STAFF REPORT
WEST ALLIS PLAN COMMISSION
Wednesday, July 27, 2022, 6:00 PM
Common Council Chambers – City Hall – 7525 W. Greenfield Ave.

5. Signage Plan for Crawdaddy's, an existing restaurant, located at 9427 W. Greenfield Ave., submitted by Troy Meyer, d/b/a Crawdaddy's. (Tax Key No. 450-0022-001)

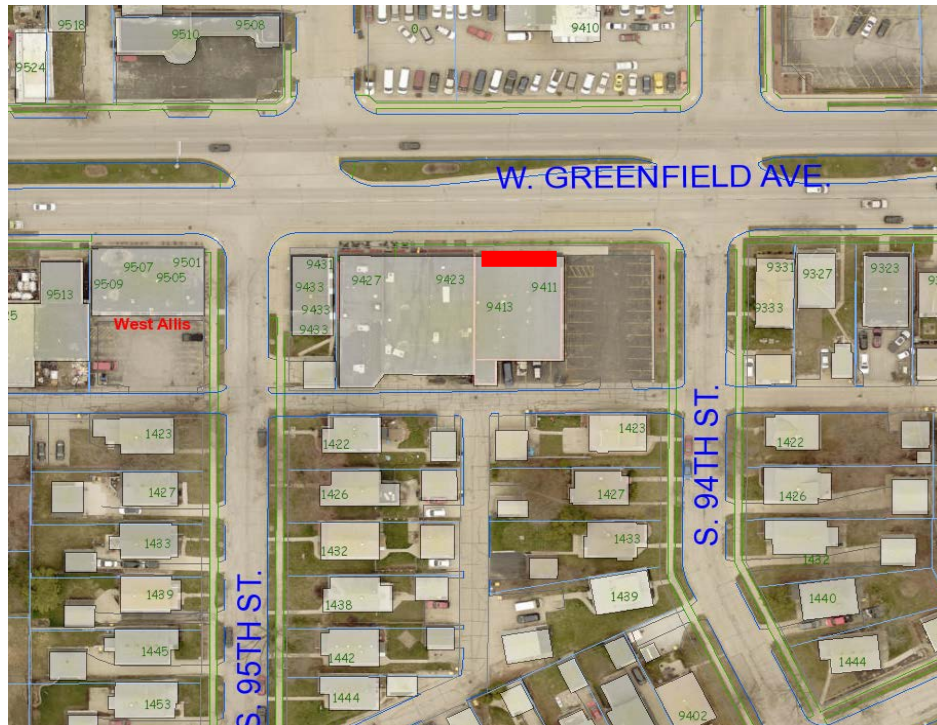
Based on the proposed design in relation to the above criteria, staff is in agreement with the applicant that these requirements have been met and believes a Creative Sign Plan should be approved. The sign features a creative way of advertising the business, provides a positive visual impact to the surrounding area and is located on a side wall so as to not cover architectural features of the building.

Recommendation: Recommend approval of the Signage Plan for Crowdaddy's, an existing restaurant, located at 9427 W. Greenfield Ave., submitted by Troy Meyer, d/b/a Crowdaddy's. (Tax Key No. 450-0022-001), based on the sign's positive visual impact, unique design and imagination, strong graphic character, inventive representation of the business and logical placement, which comprehensively satisfy the requirements of the City's Sign Code Creative Sign Subsection.

1. Signage permit - <https://www.westalliswi.gov/348/Sign-Review-Approval>
2. Floor plan and cross-section elevation with the specific anchoring system being included on in plans.
